# Product Support Bulletin 2009-007

## Maintenance of Way ~ Work Equipment Bulletin

**SUBJECT:** Anchor Chute Warning Plaque – 29300046

**MACHINE MODEL(S):** BAAM

**Figure 1**  
29300046 Anchor Tray Plaque

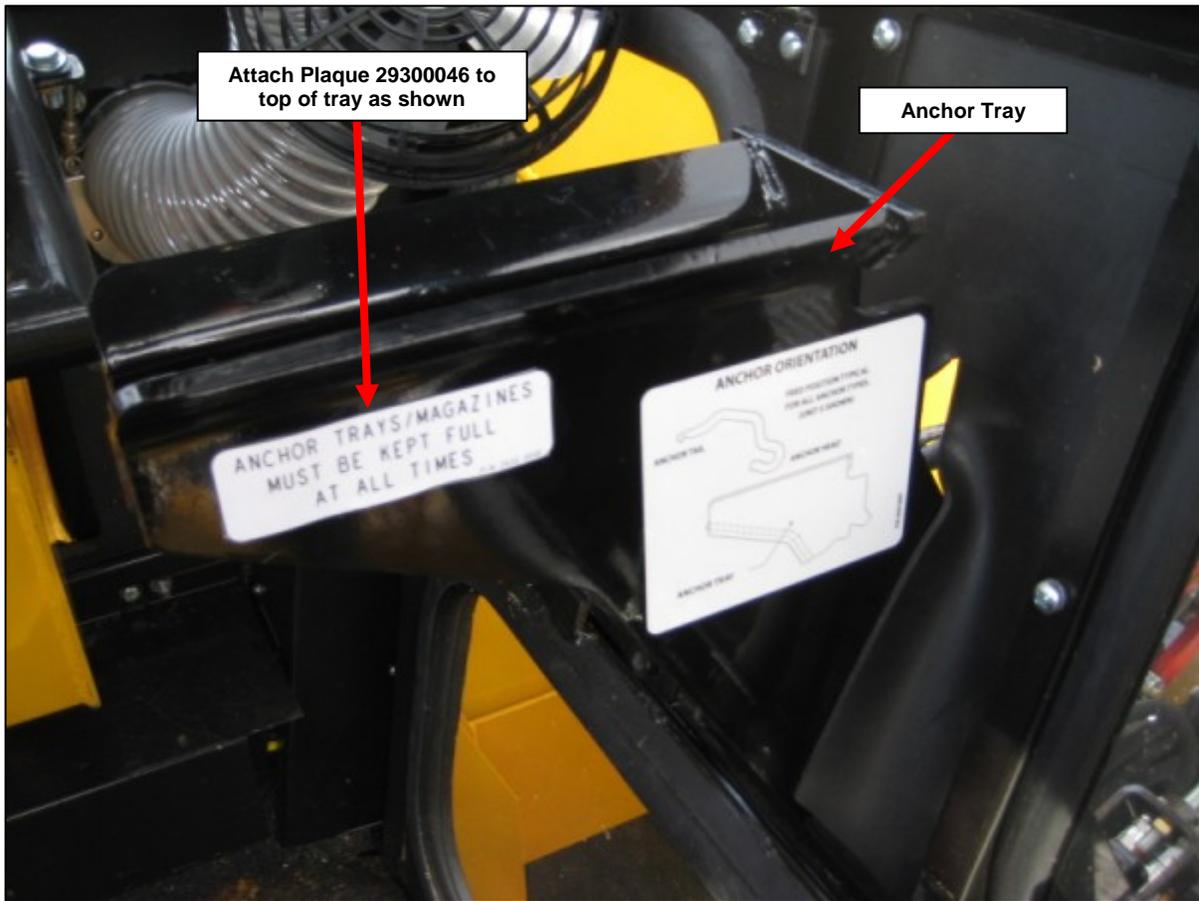
**SUMMARY:** If the anchor chutes are not kept full of anchors, the rods of the Escapement Cylinders, p/n 28550002 or 28550003, could be bent. Plaque 29300046 will remind the operator to keep the chutes full of anchors to avoid damaging the Escapement Cylinders. See Figure 1 on Page 2.

**OPERATIONAL IMPACT:** If the Escapement Cylinder rod is bent, the cylinder will not function properly and the anchors either will not drop into the Anchor Holders or will fall out on the ground.

**ACTION:** The plaques are attached to the chutes as shown in Figure 2 on Page 2. Make sure the chute is clean and free of grease and oil. Machines with serial numbers 690056 and higher have had the Plaques installed at the factory.
